STATE OF NORTH CAROLINA  
DEPARTMENT OF TRANSPORTATION

Subject: **Modification Request for Individual Section 404 Permit and to Individual Section 401 Certification for Section R-2518A**  
For US 19/US 19E Improvements  
From US 19/23 to SR 1421 (Windy Gap Road)  
Yancey County  
NCDOT Division 13  
State Project Numbers 6.869005T and 6.909001T  
T.I.P. Project Number R-2518A  
Debit \$570.00 from WBS Element 34634.1.2

PERMIT MODIFICATION  
 NOV 2, 2009 PAGE 1

PROJECT REFERENCE NO. R-2518A	SHEET NO. 30
R/W SHEET NO.	
ROADWAY DESIGN ENGINEER	HYDRAULICS ENGINEER
CONST. REV.	
R/W REV.

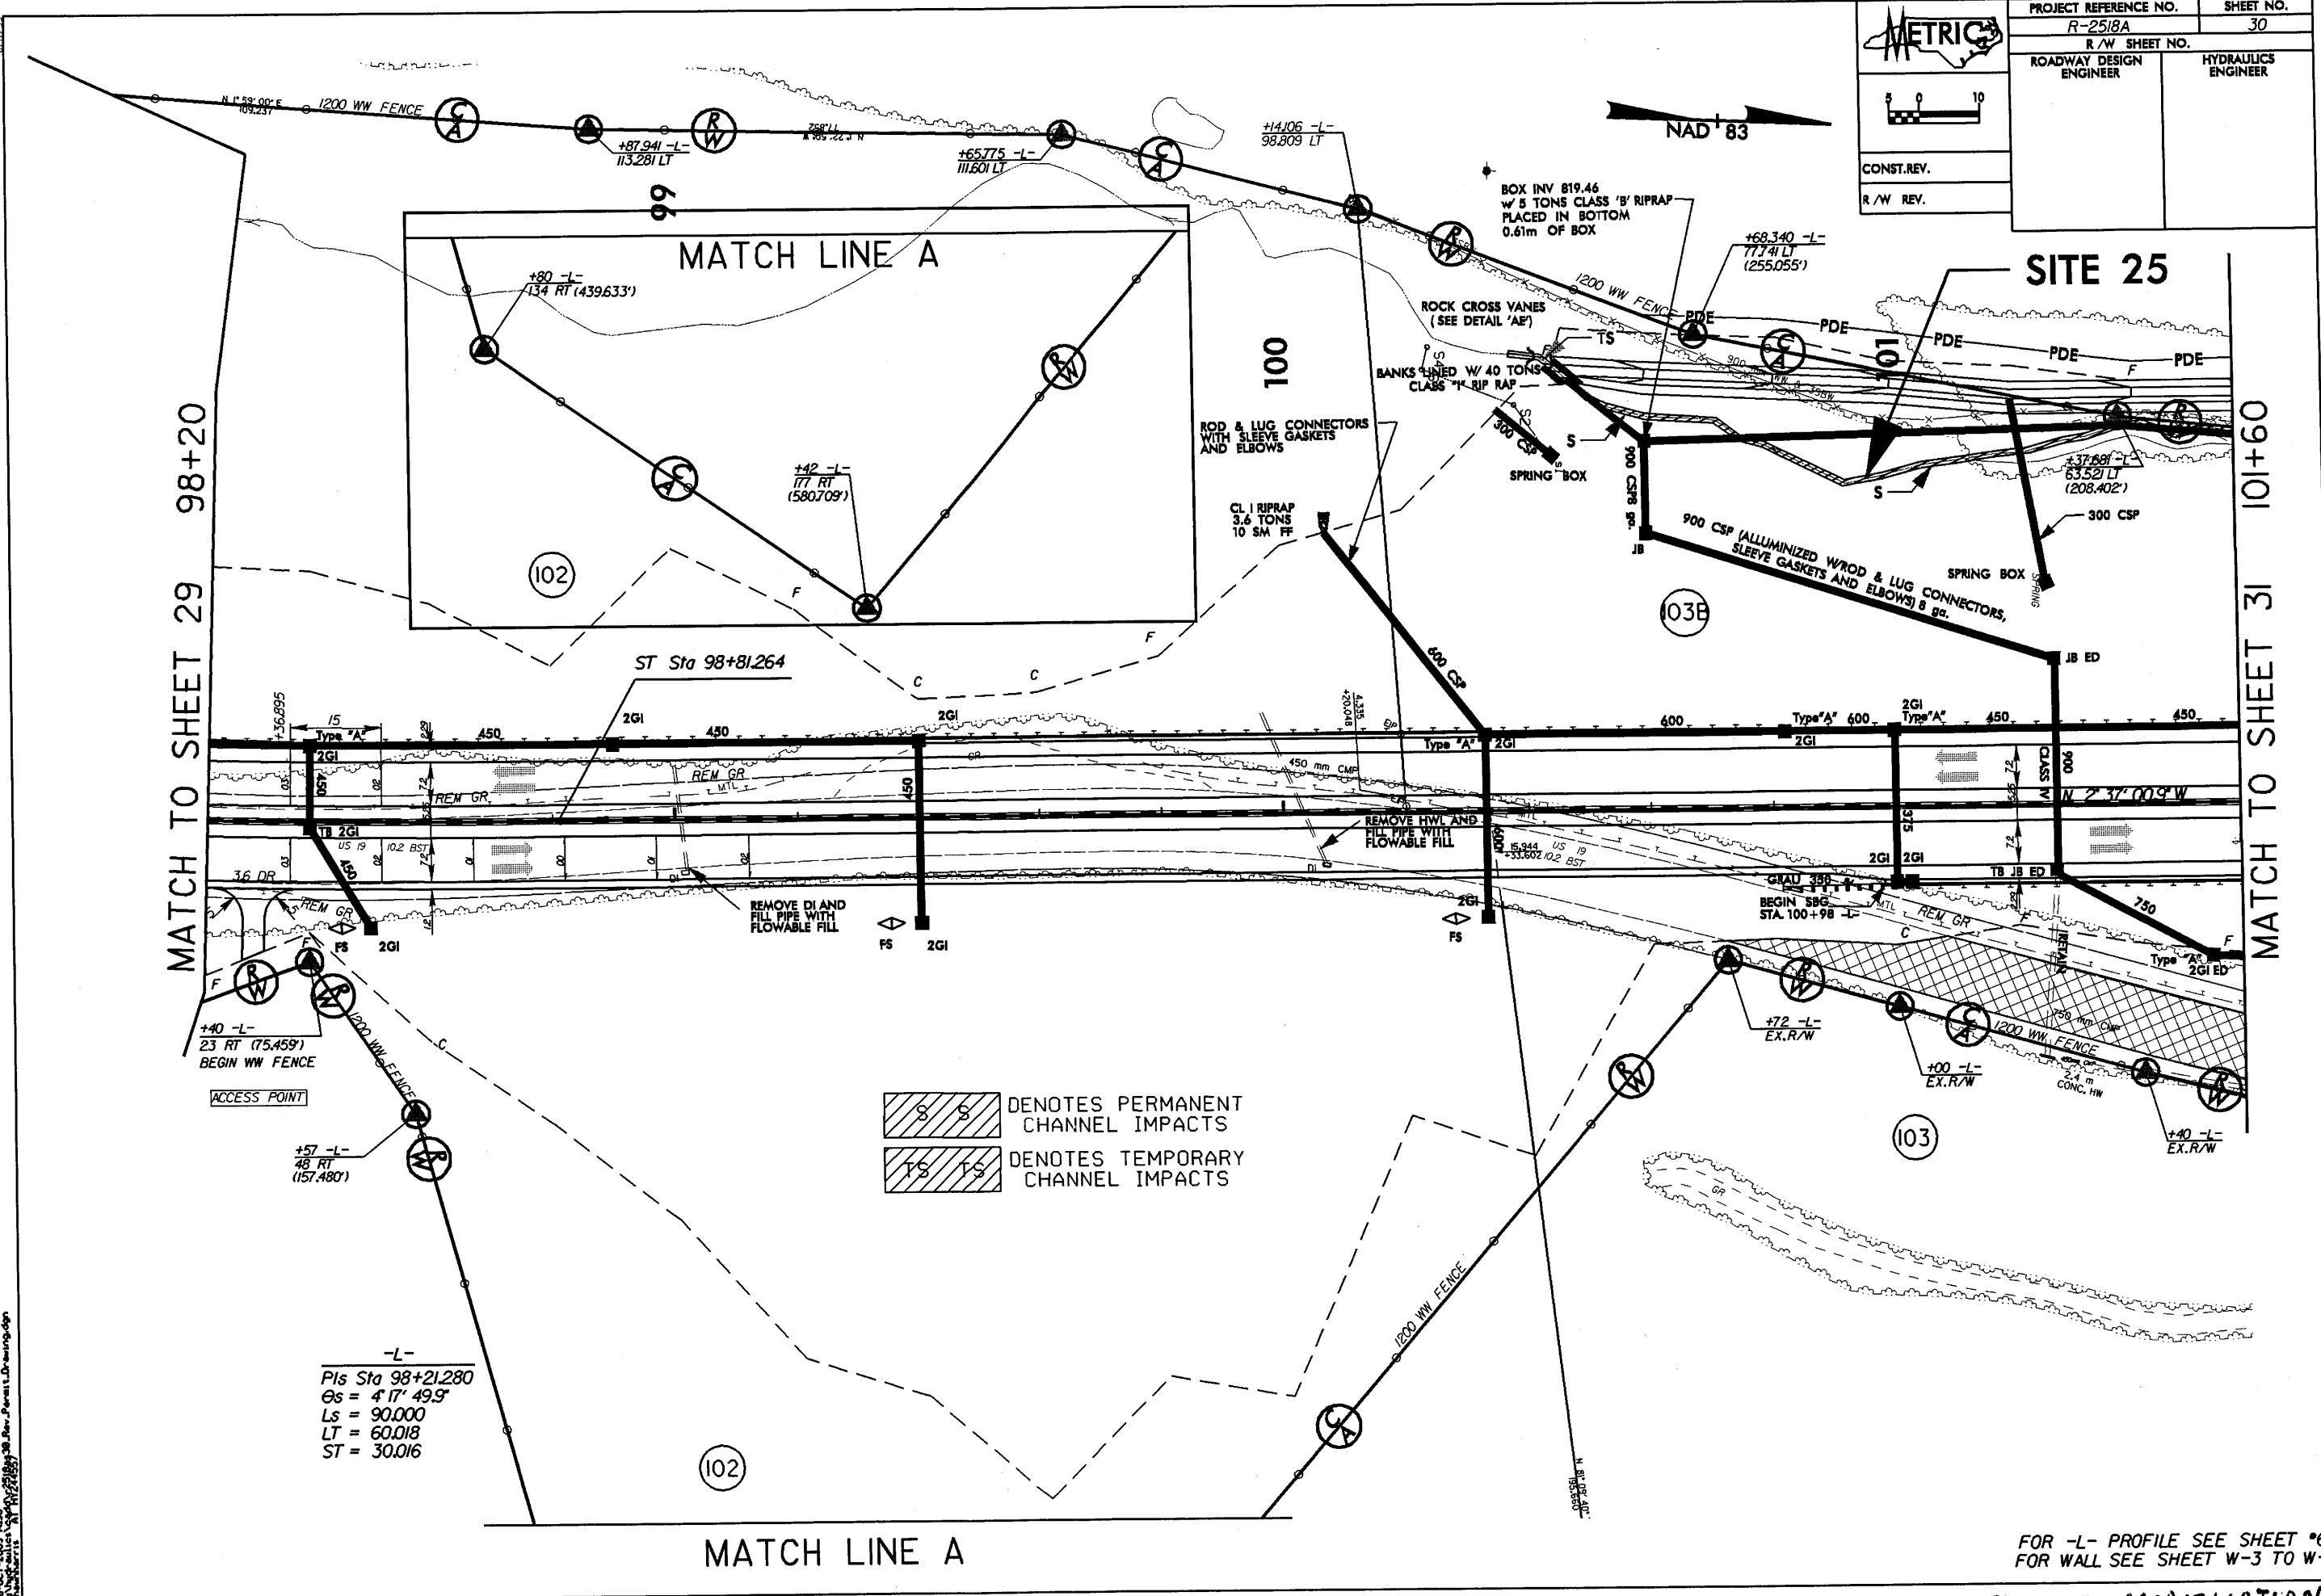
This letter addresses modifications to Section R-2518A of the 19E Widening Project that extends from US 19/23 to SR 1421 (Windy Gap Road) in Yancey County. The North Carolina Department of Transportation (NCDOT) requests approval for revisions to the above referenced permits. NCDOT proposes to eliminate a formerly planned retaining wall depicted on previously submitted Roadway Plan Sheets 30 -31 (Stations 100+80 to 103+80). This modification is requested for permanent impacts of **1,228** linear feet of Ivy Gap Branch from new culvert installation (Site 25 on attached permit drawings and impact summary sheet). The revised total stream impacts for R-2518A are 8,197 linear feet.

During the merger process a retaining wall was recommended by the Corps and the North Carolina Division of Water Quality (NCDWQ) to avoid impacts to Ivy Gap Branch. The retaining wall was originally listed as an Avoidance and Minimization measure in the June 26, 2007 Individual Permit Application. During the design process NCDOT anticipated a small toe wall approximately 10-20 feet in height. As the design progressed and geotechnical studies were completed it was determined that, due to poor soil conditions, a rock buttress was needed to prevent wall settlement and failure. Due to the buttress and proximity of the stream and roadway; the wall has increased to approximately 1000' in length, ranging from 85' to 100' in height with a construction cost of over 5 million dollars.

The fill slope that will replace the retaining wall will impact **1228** LF of Ivy Gap Branch (WSII-HQW) in the French Broad River Basin (HUC 06010105). Ivy Gap Branch from Station 97+70 to 105+00 -L- was identified as a preservation site; Site Q in Stream Mitigation Plan, US 19, R-2518A On-Site Mitigation, Madison County, North Carolina dated August 2006. The mitigation ratio that was used for preservation was 4:1. Therefore, the 1228 LF of impacts to the stream will reduce the credit received in the preservation by 307 LF (1228 LF/4). Therefore, NCDOT will impact **1228** LF of stream plus lose 307 LF of credit already used on the project resulting in a new mitigation requirement of **1535** LF. At the request of the North Carolina Division of Water Quality; NCDOT will pursue the mitigation through EEP at a 3:1 ratio.
